Inter-Office Memorandum

Date April 24, 1979 TSG-095

TMI-2 MODIFICATION CRITERIA FOR USE OF STEAM GENERATORS FOR LONG TERM COOLDOWN

(REV.3)

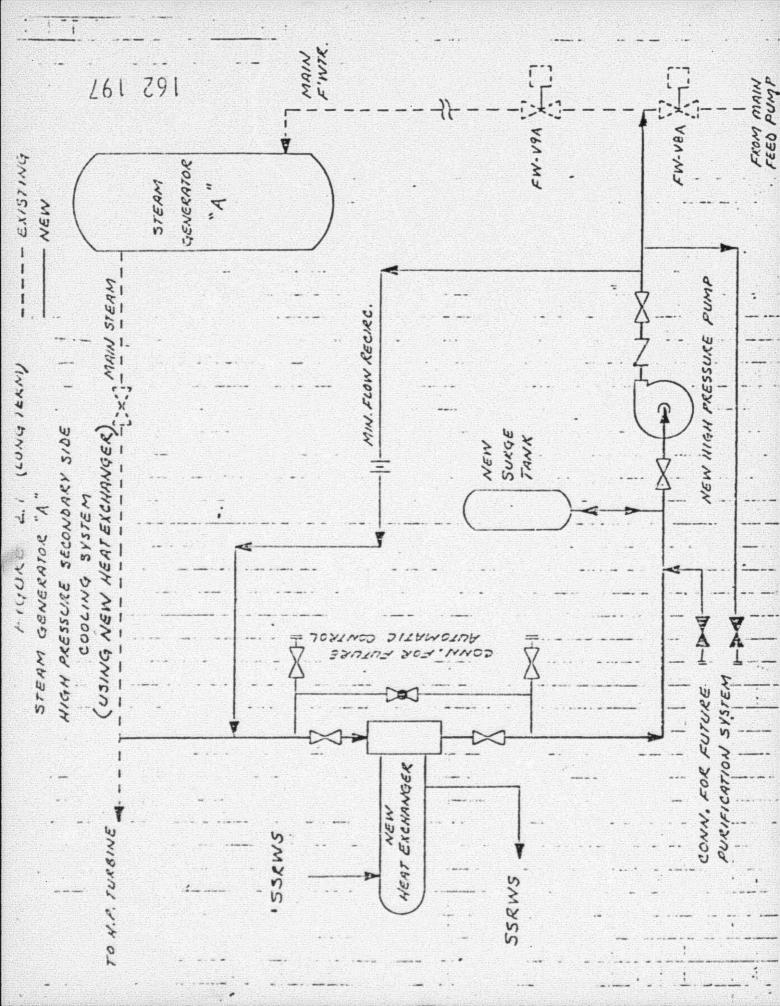
- b. The "A" steam generator criteria includes sketches for a feed to river water exchanger and for a feed to closed cooling water heat exchanger. The feed to river water scheme is preferred if a suitable heat exchanger is located.

Refer to figures, 1 + 2 attached (OTSG) cooldown - steam generator A high pressure.

The system flow path shall consist of cooled water entering the 3.5.2 steam generator through the main feedwater nozzle, exiting the steam generator through a main steam line, entering the heat exchanger and returning back to the steam generator using the system pump. The ultimate heat sink shall be provided by the nuclear services river water systems.

> On the river water side, the nuclear services river water system shall be cross-connected to the secondary services river water system to provide cooling.
